158_LET_01
20th February 2026

Regarding: Variation to Marine Licence MD-00011322 and Approval Request for Pre-Dredge Sampling Plan at Gasay, South Uist

PROJECT
GASAY FERRY TERMINAL

DRAWING TITLE
PROPOSED FERRY TERMINAL GROUND INVESTIGATION AND DREDGE DEPTH

DRAWING No.
2628-WS-FT-ZZ-DR-C-9905

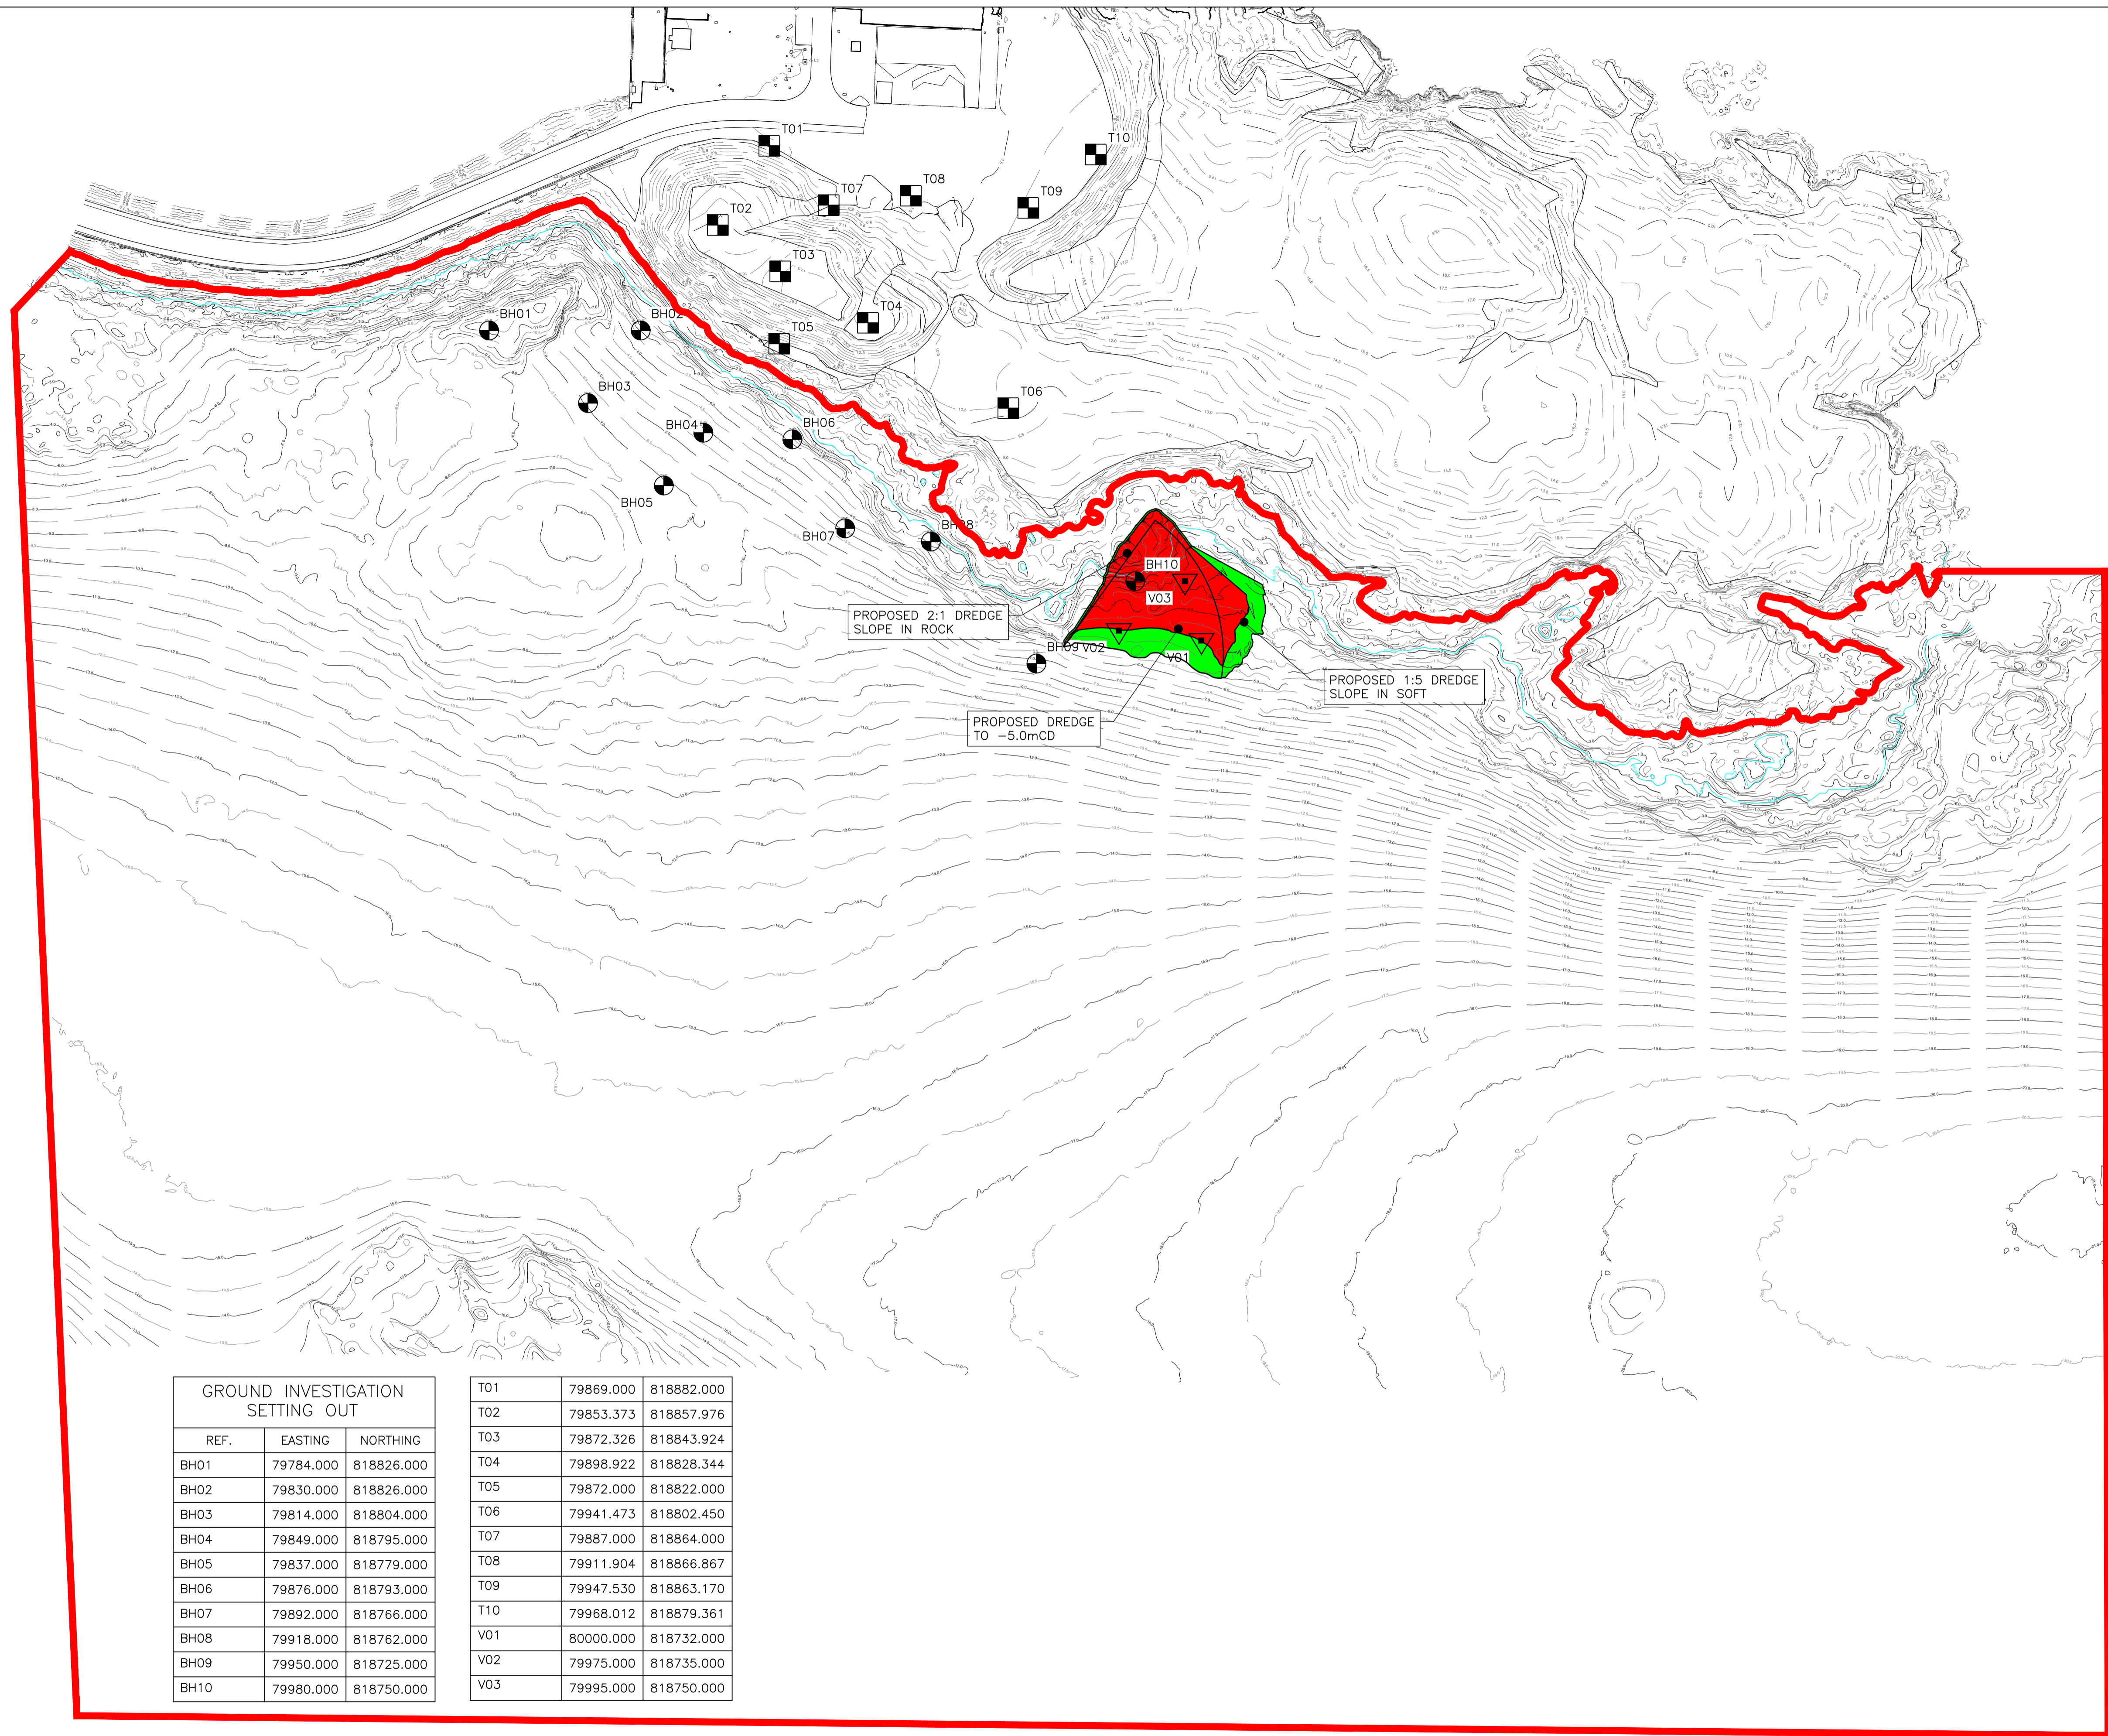
The revised, indicative sediment sampling plan is provided in Drawing 2628-WS-FT-ZZ-DR-C-9905 P01. This ground investigation plan has been amended to accommodate updated development designs, and specifically, to re-position the vibrocores into the proposed dredge pocket.

The revised sediment sampling plan will include up to 12 Cable Percussion with Rotary Core boreholes and 3 vibrocores (the location of which are discussed below for the pre-dredge sampling plan). 10 boreholes are depicted in the drawing, and an allowance for an additional two boreholes is included. This is to ensure sufficient sampling can be undertaken (up to 12 boreholes into total) to adequately represent the site characteristics.

All sediment sampling will be undertaken within the location of the Licensed Activity as per Marine Licence MD-00011322, and within 100m of the coastline. If sampling at the indicative locations depicted in Drawing 2628-WS-FT-ZZ-DR-C-9905 P01 is not possible due to seabed characteristics, sample station locations may be revised in-field to ensure representative sampling of the proposed development area.

A capital dredge campaign may be required to provide sufficient water depth for vessel manoeuvres on the approach to the proposed new berth. The dredging campaign will remove material of up to 10m depth (to -5m Chart Datum) as per the plan outlined in Drawing 2628-WS-FT-ZZ-DR-C-9905 P01. The total dredge volume will be ≤25,000m³.

Sampling will be undertaken in accordance with Marine Scotland's Pre-disposal Sampling Guidance, 2017. Three vibrocores will be taken in the indicative locations within the proposed dredge pocket as outlined in Drawing 2628-WS-FT-ZZ-DR-C-9901 P01. Vibrocores will be taken as dredge depth at these locations will be >1m. Each vibrocore will extend to at least the depth of proposed dredge in that location (unless bedrock is reached prior to the depth being achieved). Each core will be sampled at the surface layer (0-15cm), then every 50cm thereafter. Top, middle and bottom sub-samples will be analysed in line with the guidance, and all sub-samples will be retained for further analysis, if required.

Vibrocres have been re-positioned further east into the refined dredge pocket as required for pre-dredge sampling. We wish to acknowledge NatureScot's consultation response to the marine licence and recognise Gasay is known to have high densities of otter, a European Protected Species, and known otter shelter features on the south-east coast of Gasay. A pre-works check will be undertaken a maximum of 8 weeks from works commencing, and if required, a licence to disturb otter will be sought from NatureScot. No works with the potential to affect otters will be permitted until an EPS licence has been granted.
